# Service Bulletin

Bulletin No.: PI0814A

**Subject:** Steering Shudder (Vibration) During Slow Speed Maneuvers

**Models:** 2010-2013 Chevrolet Equinox  
2010-2013 GMC Terrain  
Equipped with Engine RPO LF1, LFW or LFX

2900701

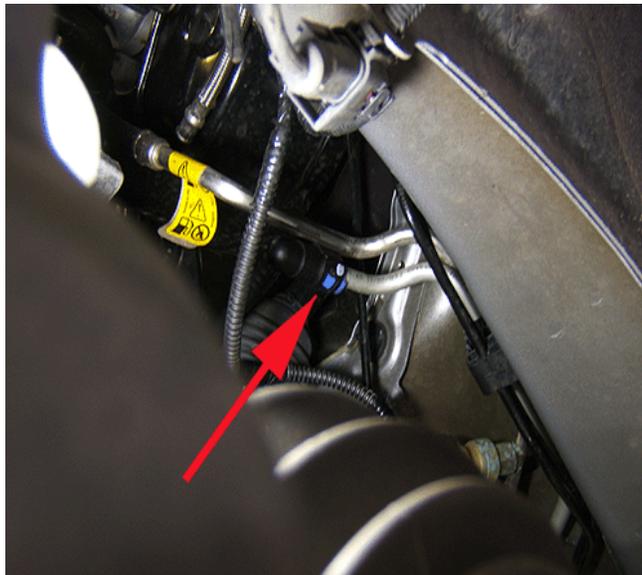
3.1. Disconnect the hose from the evaporative emission canister purge solenoid valve located by the base of the throttle body.

2900703

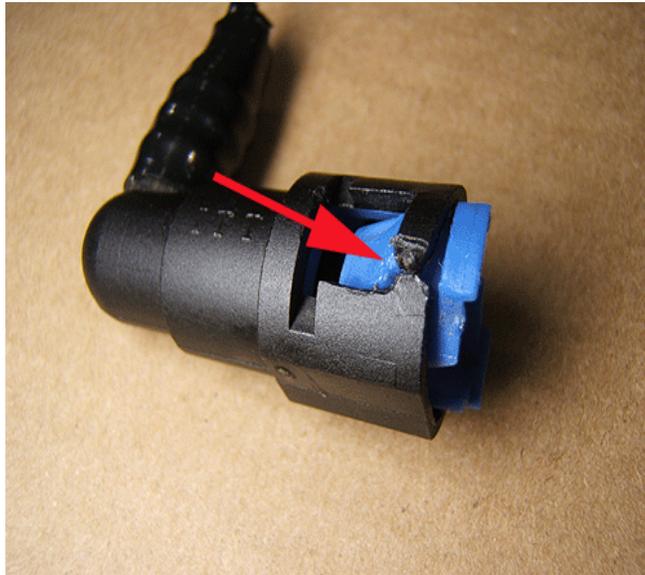
3.2. Disconnect the hose from the chassis to canister evaporative emission line.

It may be necessary to cut the plastic connector on the hose if the blue plastic retention collar cannot be released. A new connector is part of the new hose assembly.

2900708

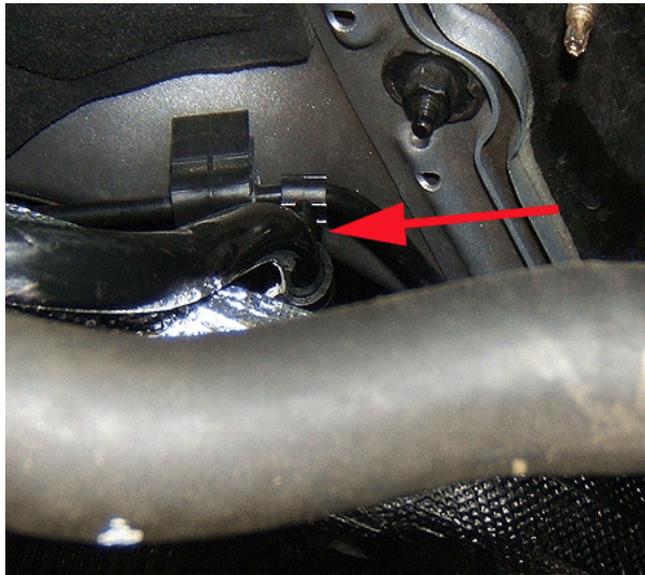
3.3. Remove the existing hose and install the new hose assembly.

Route the new hose in a way that avoids contact with chassis and body components. Connect both ends of the hose.
